Access Compliance Report Public Rights-of-Way (Curb Ramps)

Main Street: N/A		Cross Street: AVENDALE_BLVD		Location:	NE
ADA ID: RPAT220125101337	Ramp Type: Type 4 - Parallel	Initial Pass/Fail: Pass	Overall Compliance: No	Severity Score:	20
Codes/Mitigation Info/Possible Solution			Field Measurements/Component Compliance

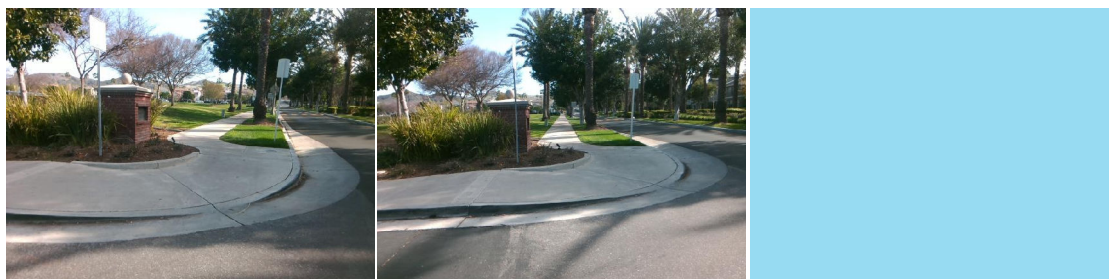
Remove & Replace Entire Ramp. Remove & Replace Gutter.
